State of New Mexico
 Energy, Minerals and Natural Resources

SUNDRY NOTICES AND REPORTS ON WELLS (DO NOT USE THIS FORM FOR PROPOSALS TO DRILL OR TO DEEPEN OR PLUG BACK TO A DIFFERENT RESERVOIR. USE "APPLICATION FOR PERMIT" (FORM C-101) FOR SUCH PROPOSALS.)		WELL API NO. 30-015-36442
1. Type of Well: Oil Well <input type="checkbox"/> Gas Well <input checked="" type="checkbox"/> Other		5. Indicate Type of Lease STATE <input checked="" type="checkbox"/> FEE <input type="checkbox"/>
2. Name of Operator Chi Operating, Inc.		6. State Oil & Gas Lease No.
3. Address of Operator P.O. Box 1799 Midland, TX 79702		7. Lease Name or Unit Agreement Name Giblet State
4. Well Location Unit Letter A : 660 feet from the North line and 660 feet from the East line Section 1 Township 19-S Range 29-E NMPM County Eddy		8. Well Number 2
11. Elevation (Show whether DR, RKB, RT, GR, etc.) 3442' KB		9. OGRID Number 004378
10. Pool name or Wildcat Turkey Track Morrow

Lease Name: Giblet State #002

API #: 30-015-36442

Lease Name: Giblet State #002

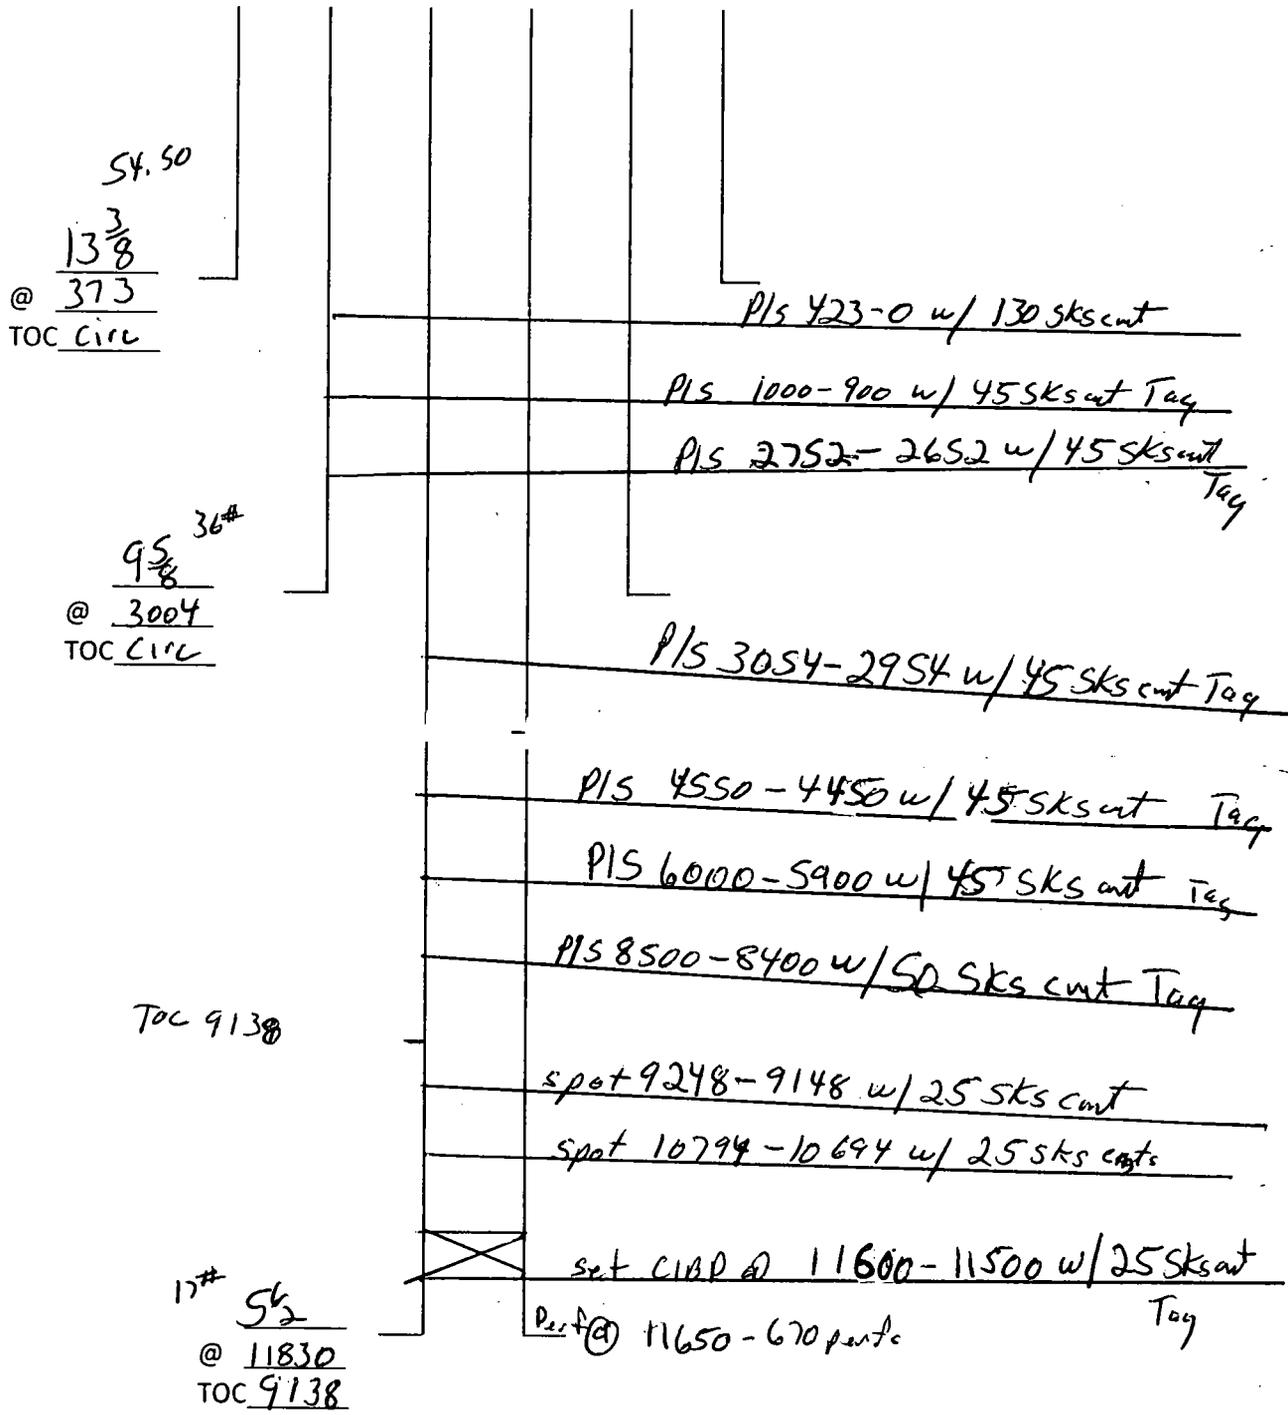
*See Attached COA's Must be Plugged by 1/10/20
